Issue List

09-25-23 CULVERS BLUE SPRINGS,MO REVIVE

Exhaustfan
09/29/2023

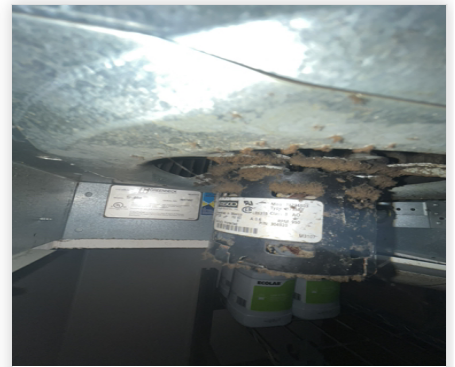
Issue Name : EF1 mop fan does not run
Description : EF1 for the mop sink was found not running. Typically there is a switch for the unit but there was no switch to be found. Recommend replacing the fan.
Created By : National TAB **Assigned To :** National TAB - Jacob Davidson
Status : Open
Originated Date : 09/29/2023 - Jacob Davidson - National TAB
